PCN-20210216a TE0712-02 DDR3, Flash Change and Product Update (Revised)

Company	Trenz Electronic GmbH
PCN Number	PCN-20210216a
Title	TE0712-02 DDR3, Flash Change and Product Update
Subject	BOM change
Issue Date	(2021-02-17), Revised 2021-03-09

This change affects all Trenz Electronic TE0712 SoMs of revision 02: TE0712-02-*

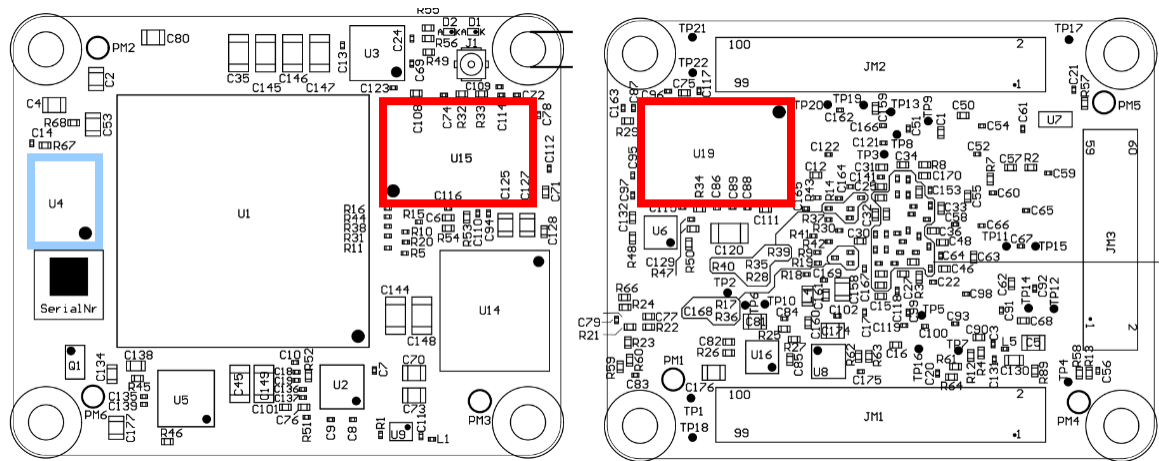
#2 Replaced Flash (U4) to IS25LP512M-RHLE All SoMs use S25FL256SAGBHI20 Flash (U4)

Type: BOM change
Reason: Ensure long time availability.
Impact: ~~Jedec Manufacturer ID changed from 01h to 9Dh, the device ID from 18h to 19h. 512Mbit flash are now available.~~

Type: BOM change
Reason: The planned IS25LP512M-RHLE is listed as 'Supported Flash Memory Devices for Artix-7 Device Configuration' in Xilinx UG908 (since version 2019.1), but there are unsolved problems with reboot after petalinux was started. Therefore this change is canceled. Only modules where other than S25FL256SAGBHI20 was used are changed to S25FL256SAGBHI20.
Impact: Jedec Manufacturer ID is 01h, the device ID 0219h. Size does not change, 256 Mbit flash are available.

Locate DDR3 RAM (U15 top, U19 bottom) and Flash (U4 top) on PCB:

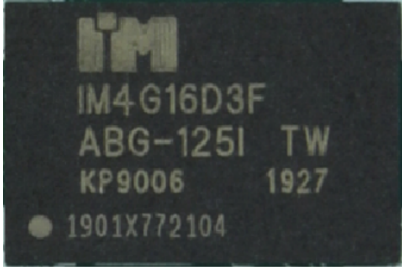
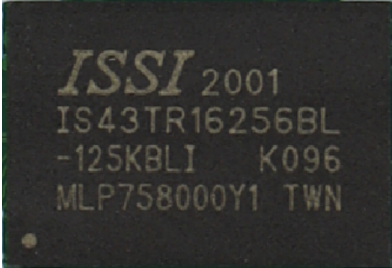
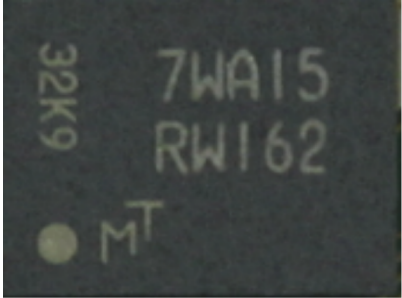
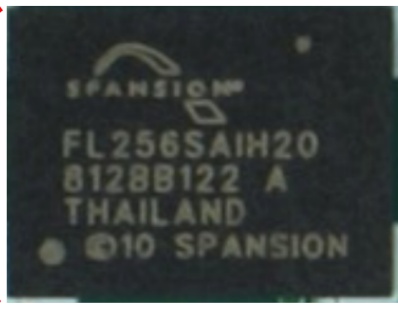
#1 Change DDR3 RAM (U15, U19) from IM4G16D3FABG-125I to IS43TR16256BL-125KBLI

#3 Clock Revision Change (U9) SiT8008AI-73-XXS-25.000000E to SiT8008BI-73-XXS-25.000000E

old	new
-----	-----

IM4G16D3FABG-125I	IS43TR16256BL-125KBLI

S25FL256SAGBH120 or MT25QL256ABA8E12-1SIT	IS25LP512M-RHLE
 TE0712-02-2CA and TE0712-02-72C03-M only:
